Anderson Ground Storage Tank No. 1 Painting and Rehabilitation Project  
SAWS Job No. 13-0129  
Solicitation No. B-15-020-DD

**ADDENDUM No. 4**

July 13, 2015

**1 TANK EXTERIOR LADDER**  
SCALE: NOT TO SCALE

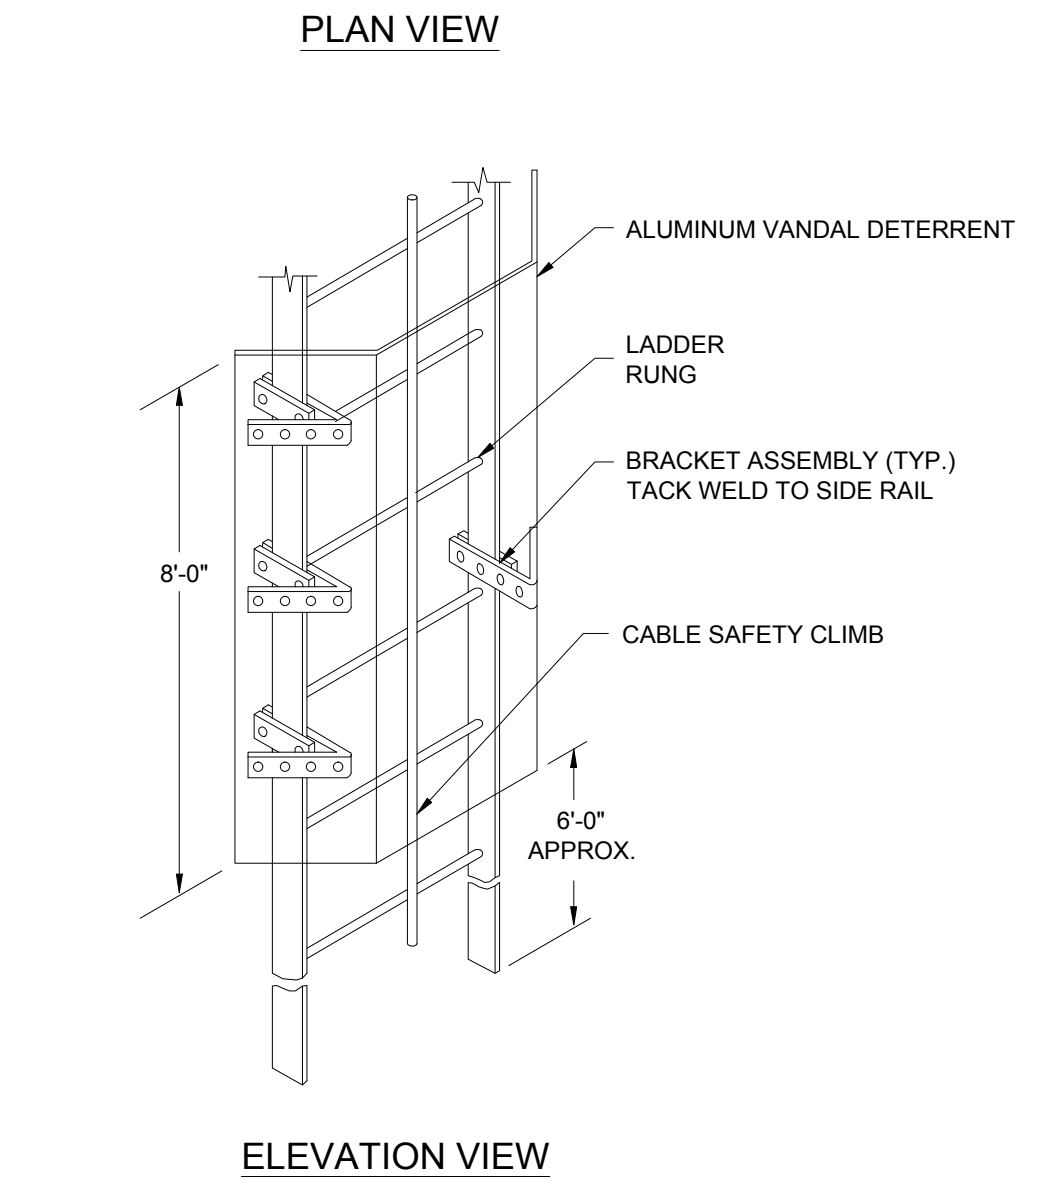
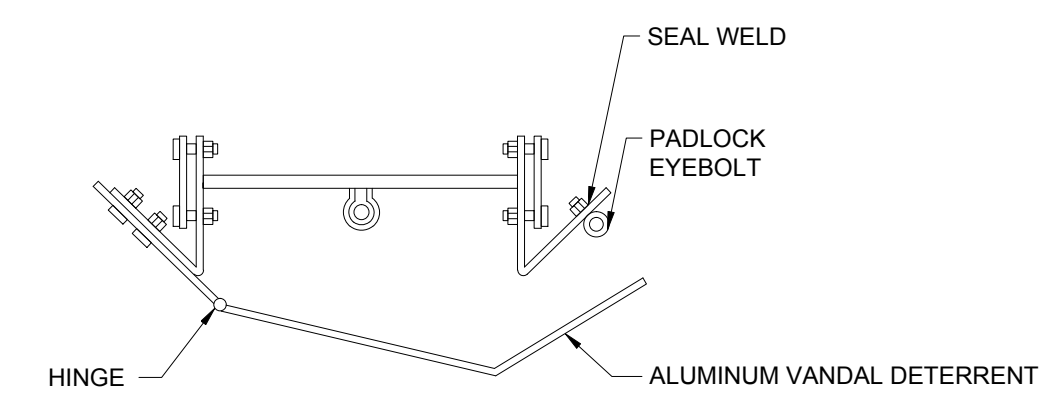
3.3 Sheet C-203

- Detail 1, revised Ladder Parapet detail reference.
- Detail 1, revised Handrail detail reference.
- Detail 1, deleted reference to SAWS detail.
- Detail 1, revised call out for fall arrest system.

4.3 Need SAWS Detail DD-903-15. Reference note on C-203 detail 1.

4.6 Reference C-203 Detail 1 Tank Exterior Ladder refers to see detail 4/S004- there is no S004.

***Response: Disregard the reference to DD-903-15, this detail is not applicable. Please see 3.3 of this addendum under Modifications to Plans.***

***Response: Revise C-203 Detail 1 note to read: "HANDRAIL SEE DETAIL 3/C-204" and "LADDER PARAPET SEE DETAIL 4/C-204". Please see 3.3 of this addendum under Modifications to Plans.***

4 TANK ROOF RAFTERS AT CHIME  
SCALE: NOT TO SCALE

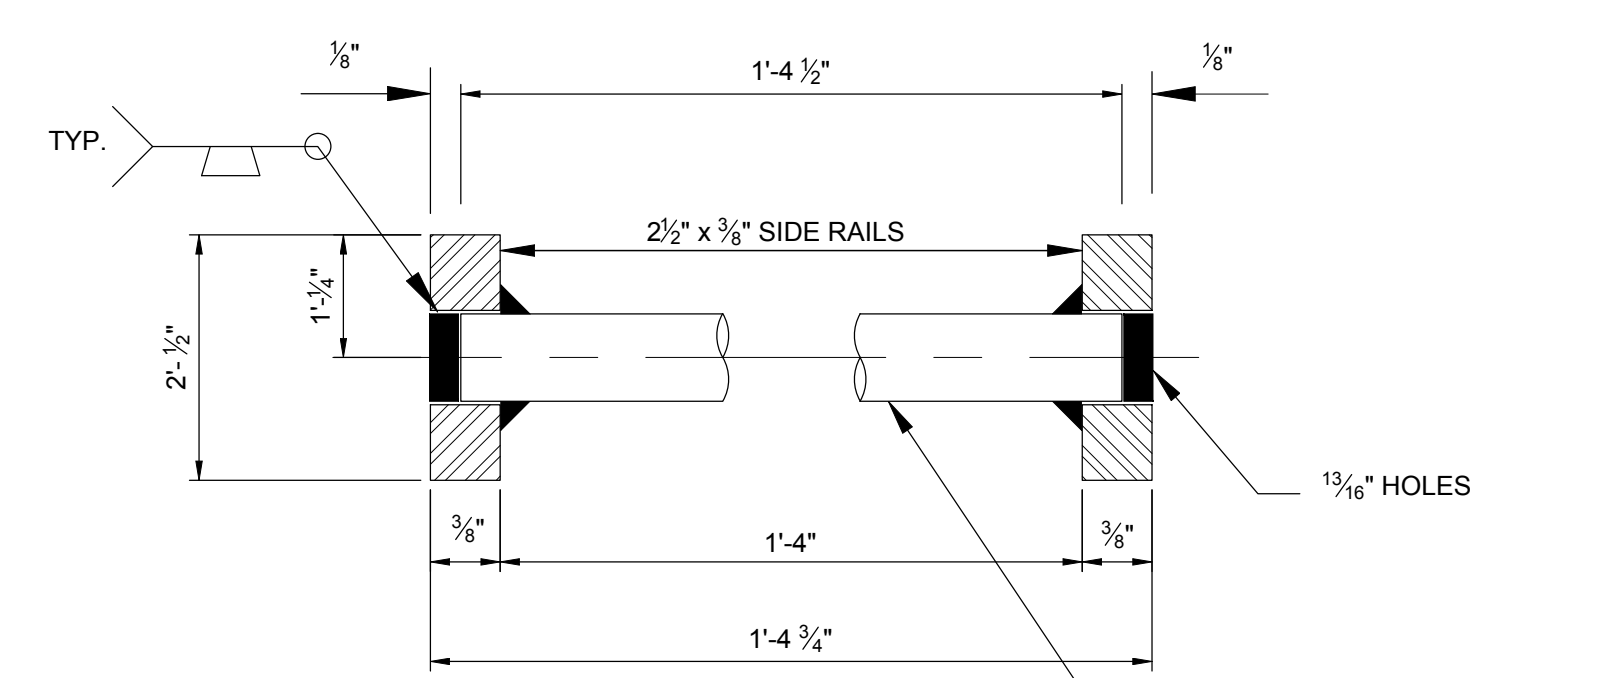
4.8 How many roof rafters are the bolts to be changed out on? The plans just say the chime.

***Response: Bolts, nuts and washers throughout the entire roof structure shall be replaced with new stainless steel bolts, nuts and washers. Please see 2.7 of this addendum under Modifications to Specifications.***
